Architectural Review Board

August 23, 2022 – 5:30 p.m.

III. Full Review of Items

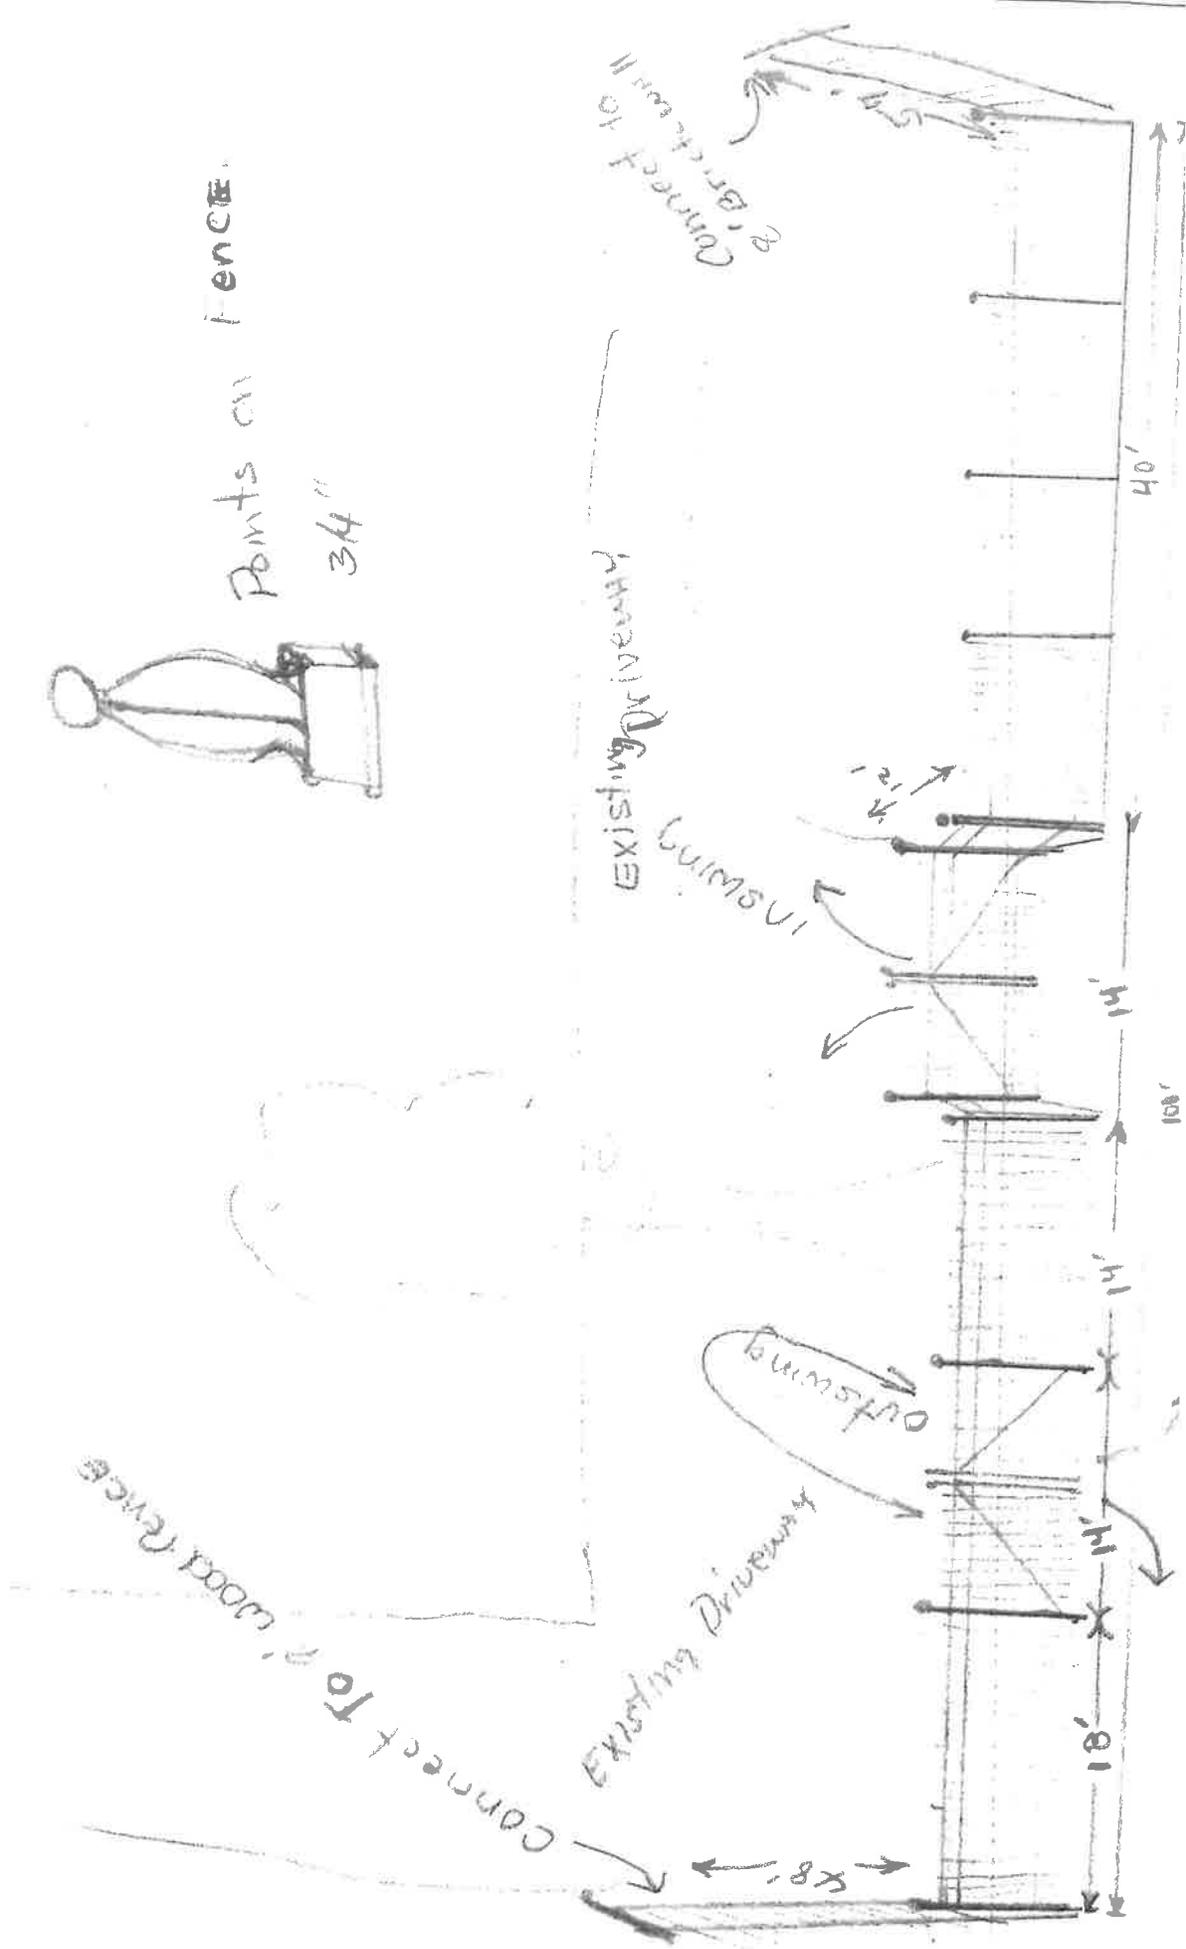
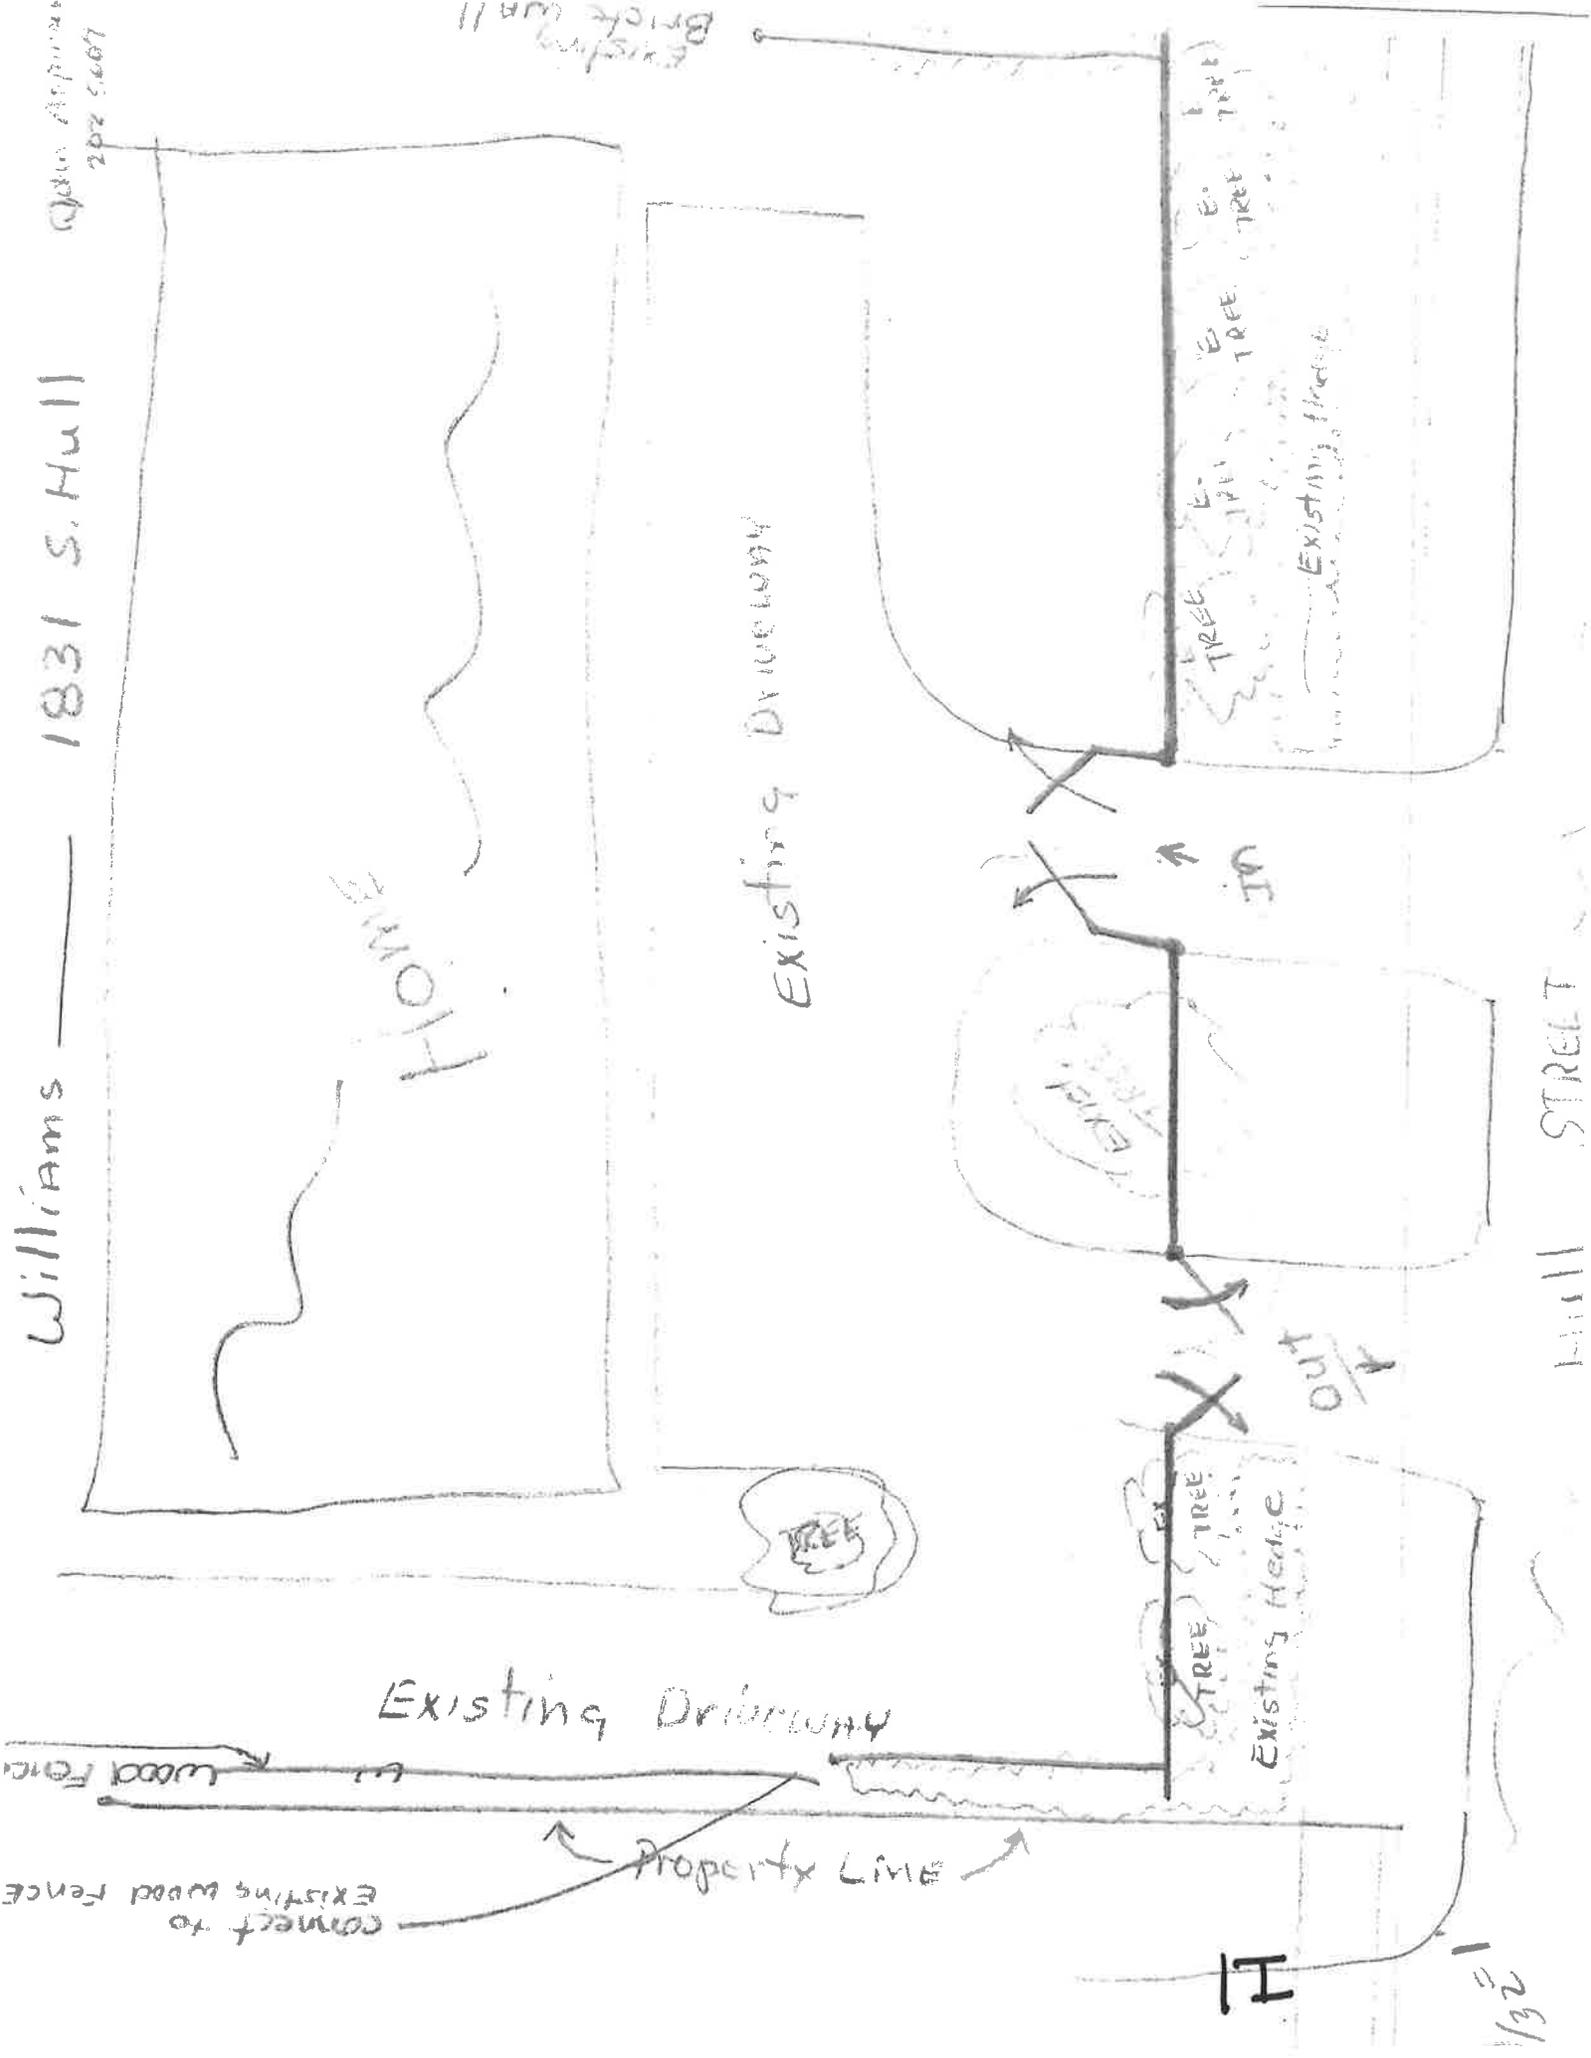
- Front yard and street facing fences historically were 36”-48” in height where they meet the sidewalk. However, the Board has approved taller fences near front property lines or on corner lots when they were placed behind a hedge: 628 Thorn, 704 Felder, 407 E Fairview, 100 Felder, and most recently, 1490 S. Perry Street.
- No variance required with a see through fence in this location.
